Submit 3 Copies To Appropriate District Offece	State of New Mexico	Form C-103
District I Property Energy	y, Minerals and Natural Resources	June 19, 2008
Energy, Minerals and Natural Resources 1625 N French Dr , Hobbs, No. 2007 P. Minerals and Natural Resources District II		WELL API NO. / 30-025-25056
1301 W Grand Ave, Artesia, NOTS88210 A. 70661 CONSERVATION DIVISION		5. Indicate Type of Lease
1220 Douth St. 1 failets D1.		STATE FEE
District IV 1220 S St. Francis Dr., Santa Fe, NM		6. State Oil & Gas Lease No.
87505		
SUNDRY NOTICES AND REPORTS ON WELLS (DO NOT USE THIS FORM FOR PROPOSALS TO DRILL OR TO DEEPEN OR PLUG BACK TO A		7. Lease Name or Unit Agreement Name H.T. MATTERN NCT-D
DIFFERENT RESERVOIR USE "APPLICATION FOR PERMIT" (FORM C-101) FOR SUCH		H.T. MATTERN NCT-D
PROPOSALS) 1. Type of Well: Oil Well Gas Well Other		8. Well Number 12

2. Name of Operator		9. OGRID Number 4323
CHEVRON U.S.A. INC.		
3. Address of Operator		10. Pool name or Wildcat
15 SMITH ROAD, MIDLAND, TEXAS 79705		BLINEBRY/TUBB/DRINKARD

13. Describe proposed or completed operations. (Clearly state all pertinent details, and give pertinent dates, including estimated date of starting any proposed work). SE

Matterrn H T#12-WBD xls 9/10/2009 6 28 AM

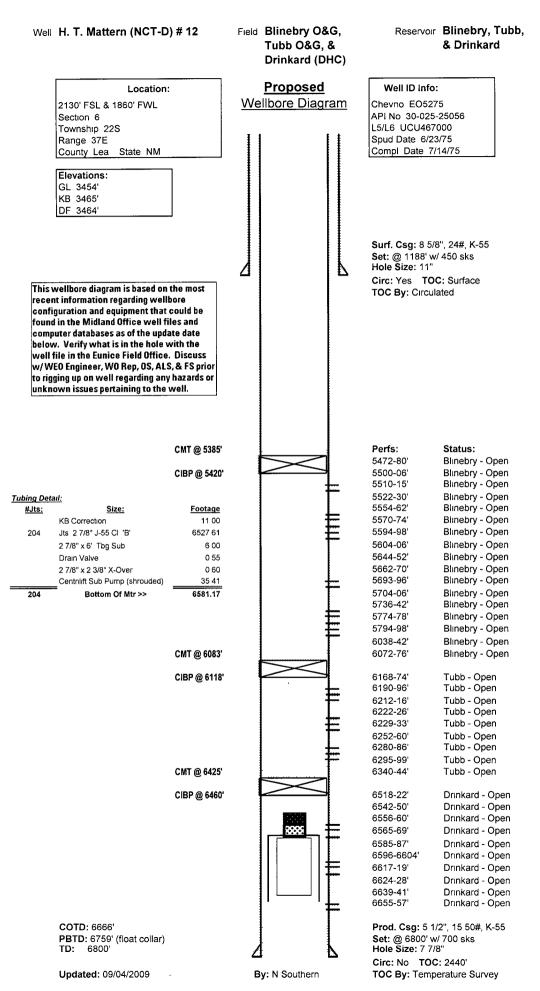
****This is an amended request****		
The bottom plug will be set deeper than originally planned: Intent to set CIBP @ 6460', Cmt @ 6425'		
See attached amended wellbore diagram Condition of Approval: Notify OCD Hobbs		
office 24 hours prior to running MIT Test & Chart		
C ID	Pia Palassa Parter	
Spud Date:	Rig Release Date:	`
I hereby certify that the information above is true and complete to the best of my knowledge and belief.		
$A \leftarrow \sum_{i} A_{i}$		
SIGNATURE THE SULLATORY SPECIALIST DATE 09-10-2009		
SIGNATURE VINGS TO TITLE REGULATORY SPECIALIST DATE 09-10-2009		
Type or print name DENISE PINKERTON E-mail address: <u>leakejd@chevron.com</u> PHONE: 432-687-7375		
For State Use Only DISTRICT 1 SUPERVISOR SEP 1 4 2009		
APPROVED BY: TITLE DATE		
Conditions of Approval (if any).
